Fixing DLL and LLDP

D1.7 comment # 98, v6

Draft 1.7 Comment #98

PD DLL power control State Diagram (SD)

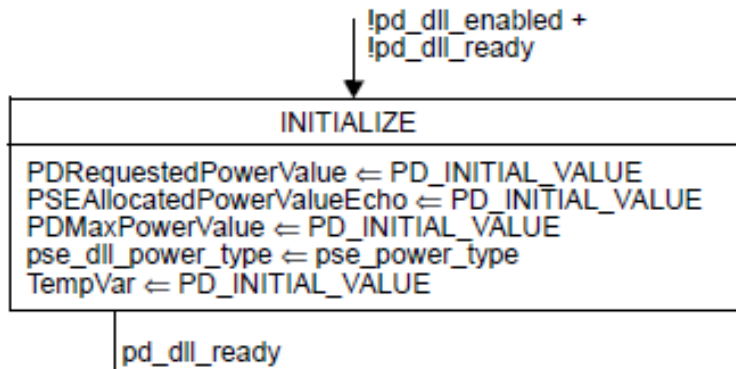
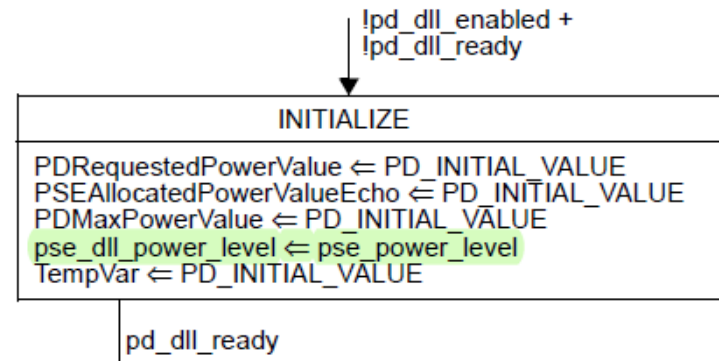
The San Antonio 2014 meeting presentation, Mutual_ID_PD_updated, change variable **pse_dll_power_type** was changed to **pse_dll_power_level**.

This change:

1. Broke legacy DLL power control.
2. Broke DLL classification for new Types.

On page 175, restore the legacy SD.

Type 3,4 PD State Diagram

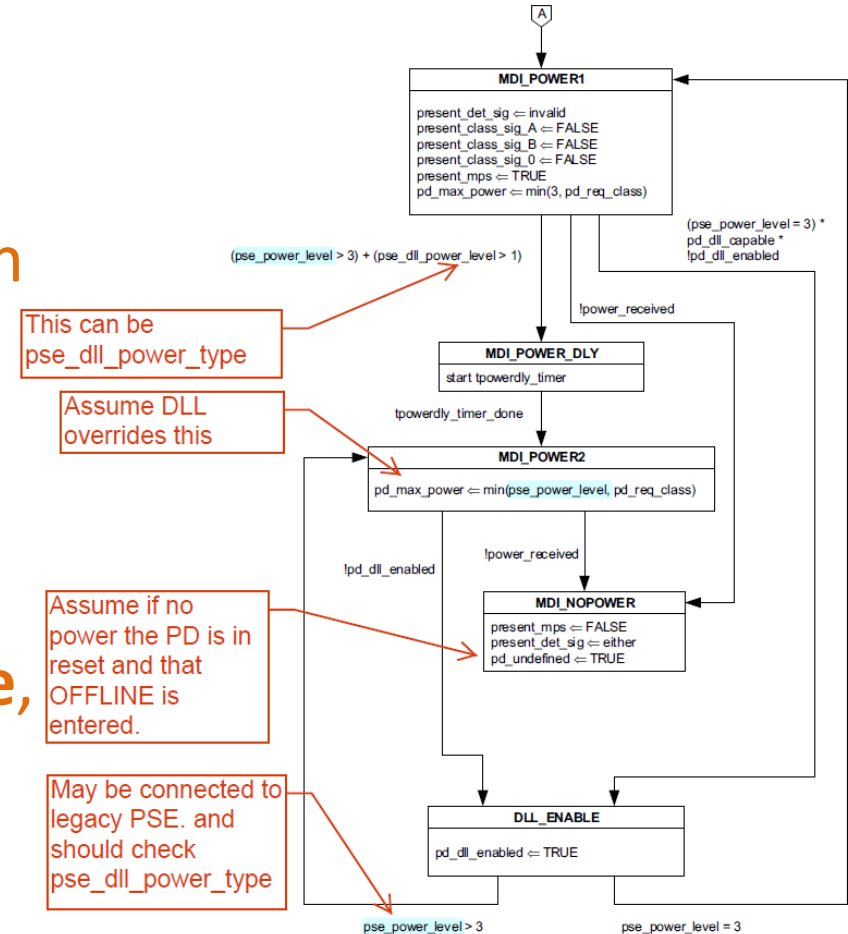
New >class-3 PDs are required to support DLL, **pse_dll_power_level > 1 for this case** (i.e. >class 3 or legacy Type >1).

On page 129,

MDI_POWER1 test replace
pse_dll_power_level with
pse_dll_power_type.

DLL_ENABLE tests should
replace **pse_power_level**
with **pse_dll_power_type**,
change 3 to 1.

Fix LLDP TLV Variables

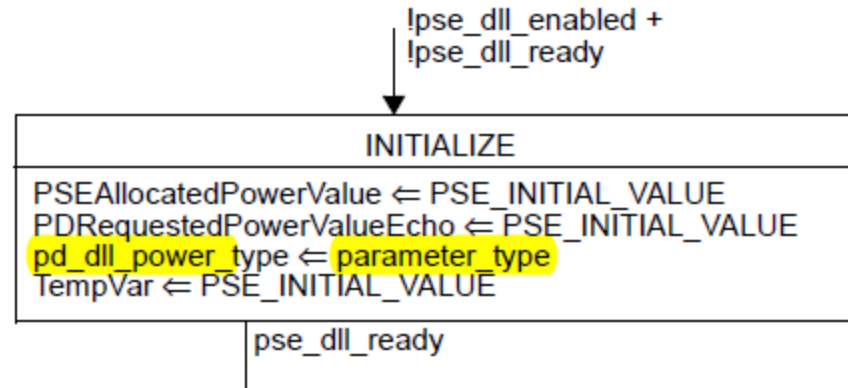
On page 218, new TLV variable and object class attributes are required, change

Power class	aLldpXdot3RemPowerClass	31
		32
Power type	aLldpXdot3RemPowerType	33
		34

to Power class~~x~~ aLldpXdot3RemPowerClass~~x~~

Power type~~x~~ aLldpXdot3RemPowerType~~x~~

Note that legacy Power class and Power type rows remain the same.
